WOODLAND GLEN SUBDIVISION

APPLICATION NUMBER 23 DATE April 6, 2006

DETAIL SITE PLAN

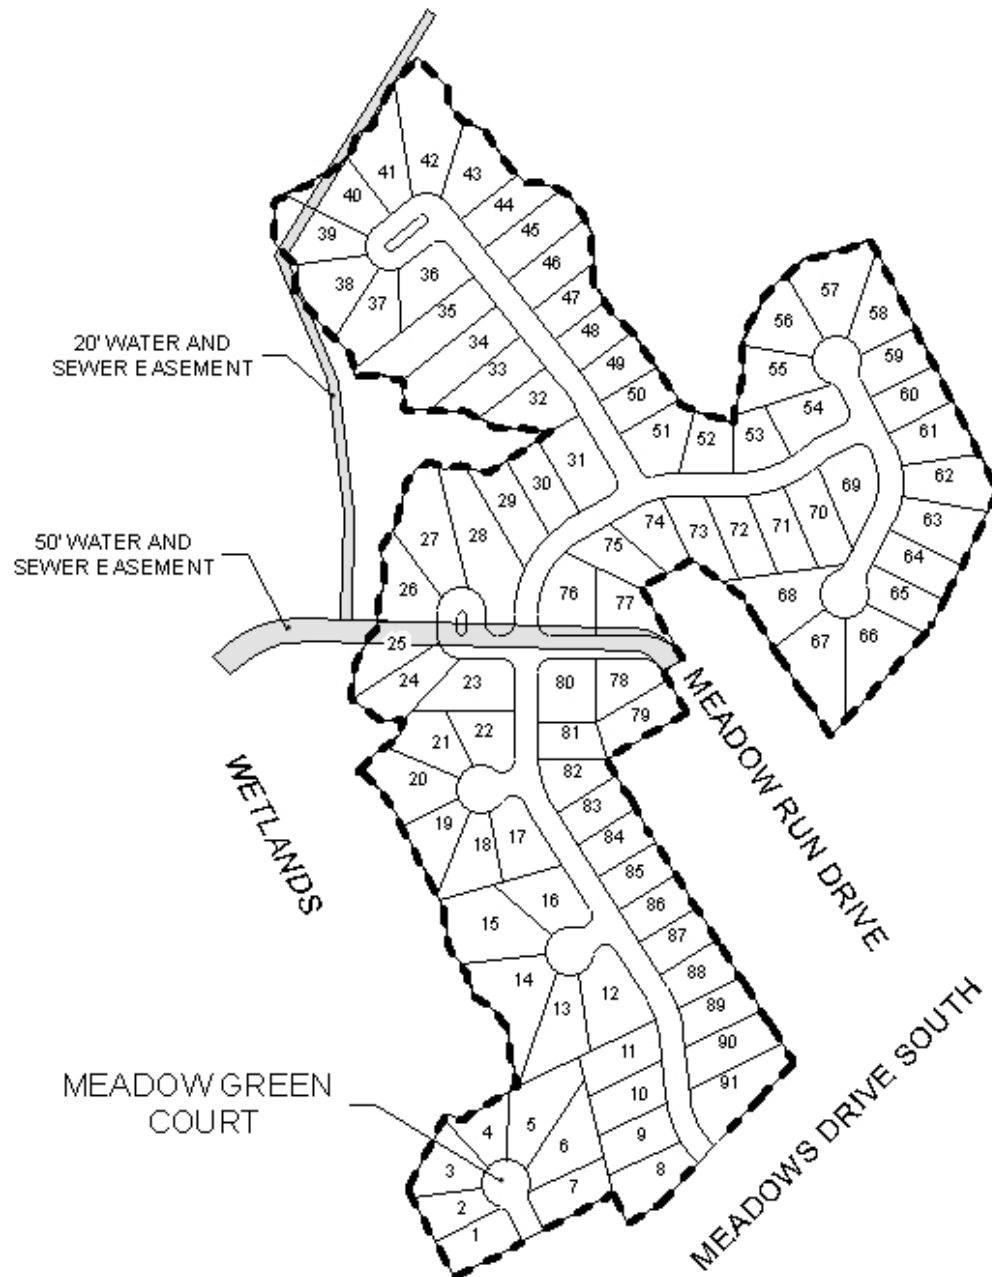
The proposed subdivision has frontage onto street stubs for Meadow Green Court and Meadow Run Drive, both minor streets with adequate rights-of-way, as well as an implied new connection to Meadows Drive South. The preliminary plat should be revised to show the continuance of the proposed right-of-way to Meadows Drive South, rather than depicting it as what appears to be a lot. No additional street stubs are proposed as part of the Woodland Glen subdivision.

Woodland Glen Subdivision. Therefore, provision of a street-stub to connect to the proposed Saybrook Subdivision should be required.

A 50-foot wide easement to the Board of Water and Sewer Commissioners runs along Meadow Run Drive, and proceeds through the proposed subdivision, exiting on the West side through proposed Lot 25. The proposed right-of-way does not exactly coincide with the easement, thus the subdivision should be redesigned so that the centerline of the proposed road right-of-way aligns with the centerline of the existing easement. Furthermore, it should be noted that a substantial portion of proposed Lot 25 would not be considered buildable due to the presence of the easement.

The 25-foot minimum building setback line from the right-of-way is not shown but would be required on the Final Plat, if approved.

Based upon the proceeding, the plat is recommended for Holdover for the following reasons: 1) revision of the plat to include the full extent of all parcels; 2) revision of the plat to show the right-of-way aligned with the existing water and sewer easement; 3) revision of the plat to depict a right-of-way connection to Meadows Drive South; and 4) provision of a composite plan to address connections between existing street stubs, land-locked parcels, and the proposed subdivision, or subdivision of the remainder of the parcels to represent future development phases for the four existing subdivisions that stub into the parcels in question.
